Item ID: D206-667-207BL Accept ***N900040100*** Setup Start ***NS1***
Revision ID: Stop ***NS2***
Item Name: Aft Crosstube - Mid Height 206L / L1 / L3 / L4, Blue
Start Date: 10/28/2015 Start Qty: 1.00 ***1*** Cust Item ID:
Required Date: 10/28/2015 Req'd Qty: 1.00 ***1*** Customer:
Reference:

DART AEROSPACE LTD HAWKESBURY, ONTARIO, CANADA	
DRAWING NO. D206-667-247	REV. A SHEET 1 OF 4
TITLE CROSSTUBE ASS'Y (206L MID AFT)	SCALE NTS

DRAWING NO. D206-667-247	TITLE CROSSTUBE ASS'Y (206L MID AFT)	REV. A	DART AEROSPACE LTD ENGINEERING ORDER		D.E.O. NO. D206-667-247-A-1	SHEET NO. SHEET 1 OF 1	SCALE NTS
DRAWN 92	CHECKED ASS	MFG. APPR. KD	APPROVED JMP		DE APPR. #		
DATE 11.07.15	DATE 11.07.20	DATE 11.07.21	DATE 11/07/21		DATE 11.7.21

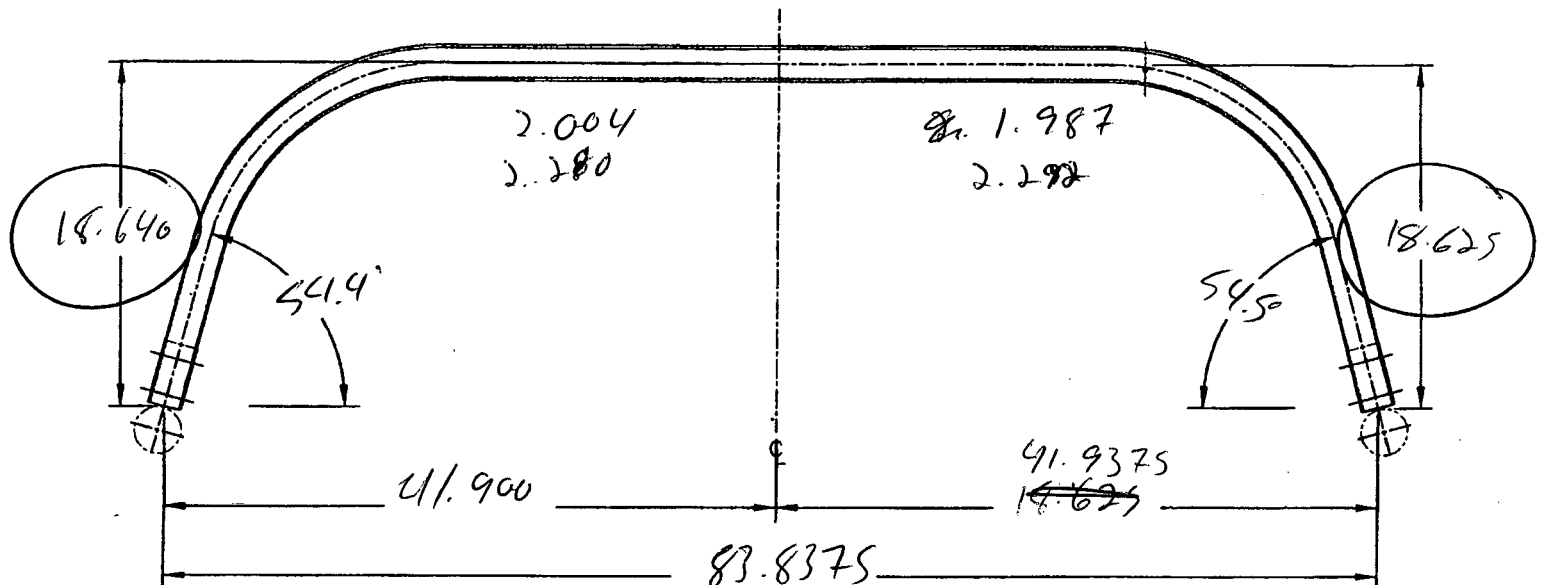
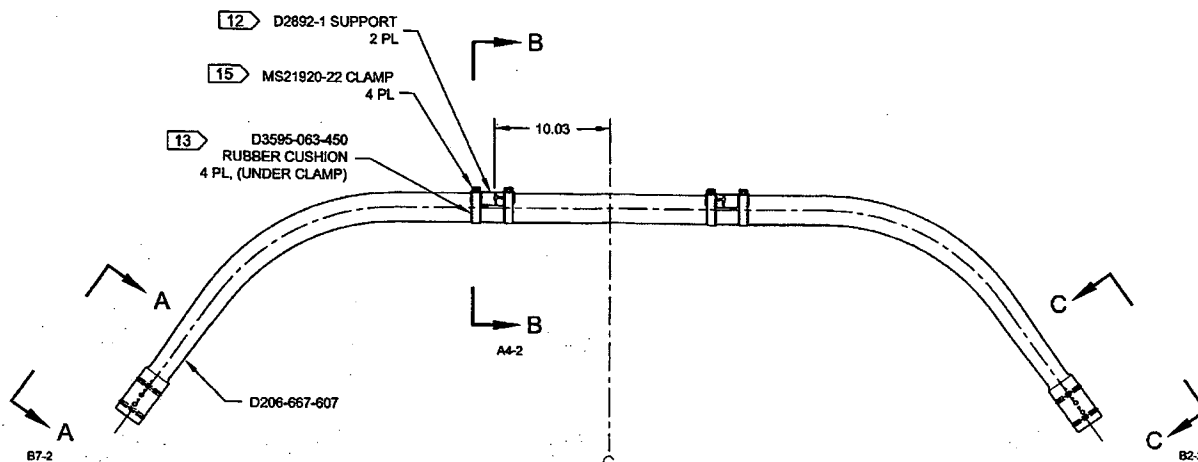
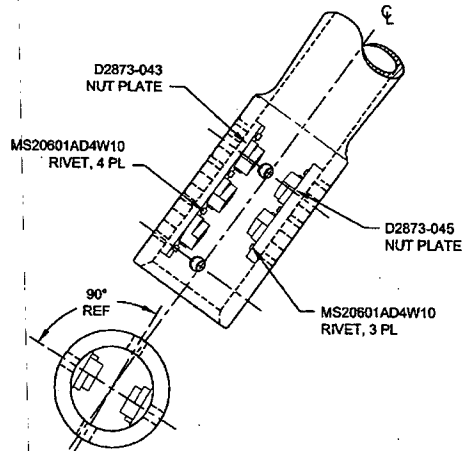
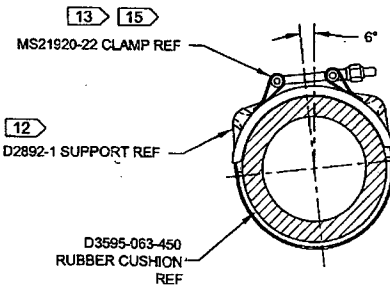
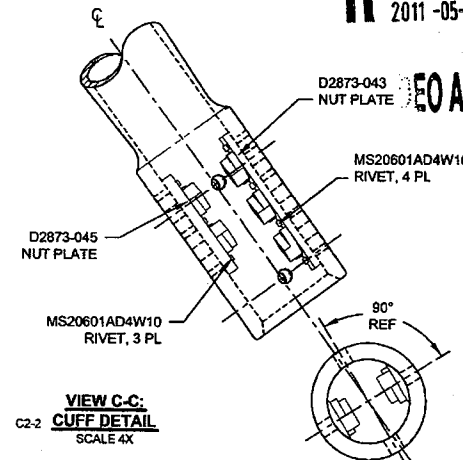
PURPOSE:

REPLACE MAGNOBOND WITH PROSEAL.

Item	Qty -247	Part Number	Description
9	A/R	PROSEAL 890 B-2	SEALANT, AMS-S-8802 CLASS B-2

9	A/R	MAGNOBOND 6398	ROCKWELL SPECIFICATION RBO-120-023 ADHESIVE (TEXTRON/BELL SPEC. 299-947-100, TYPE II, CLASS 2 ADHESIVE)
---	-----	----------------	---

NOTE 12 & 15, SHEET 1 IS AMENDED AS FOLLOWS:

- 12) INSTALL D2892-1 SUPPORT USING 0.03" TO 0.06" THICK LAYER OF MAGNOBOND 6398 PER QSI 015. LET CURE FOR 12 HOURS AFTER INSTALLATION AND PRIOR TO PACKAGING.
- 15) TORQUE CLAMPS 80 TO 100 IN-LB. ENSURE AT LEAST 1.5 THREADS SHOWING IN SAFETY AND THAT NUT HAS NOT BOTTOMED-OUT AFTER TORQUING.

- 12) TO INSTALL D2892-1 SUPPORT: ABRASE MATING SURFACE OF SUPPORT AND CROSSTUBE WITH 180-GRIT SANDPAPER AND REMOVE RESIDUE WITH MEK (OR EQUIVALENT). APPLY A 0.04" TO 0.07" THICK LAYER OF PROSEAL 890 CLASS B-2 (OR AMS-S-8802 CLASS B-2) SEALANT TO MATING SURFACE OF SUPPORT.
- 15) TORQUE CLAMPS 80 TO 100 IN-LB. ENSURE AT LEAST 1.5 THREADS SHOWING IN SAFETY AND THAT NUT HAS NOT BOTTOMED-OUT AFTER TORQUING. **PRIOR TO PACKAGING, RE-CHECK TORQUE ON CLAMPS AFTER PROSEAL 890 SEALANT HAS CURED FOR 72 HOURS.**
